September 20, 2007

REF: Men's Wearhouse
27500 Novi Road

A CUSTOM REVERSE LIT CHANNEL LETTERS ON BACKER PANEL

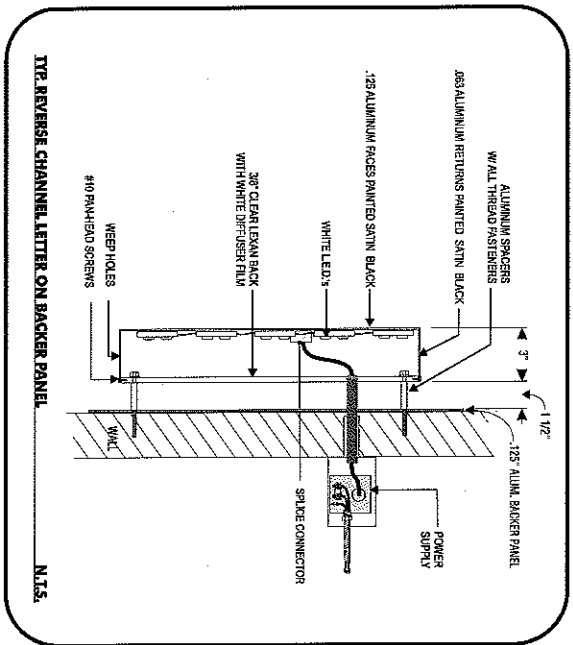
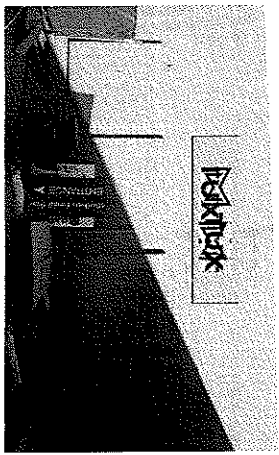
We have reviewed the sign permit application that you recently submitted for the above business to this Department. At this time the application is **DENIED**. This tenant does not have a pedestrian entrance to the business from outside the building that is required under Sec 28-5(3)f of the Novi Sign Code, which was based on the approval for the sign for the former tenant in this space.

You may apply to the Zoning Board of Appeals for a variance request within thirty (30) days of the date of this letter. After the thirty day limit, your application will be regarded as abandoned. Your contact person for the Zoning Board of Appeals is Robin Working in the Building Department. You may reach her at 248-347-0580.
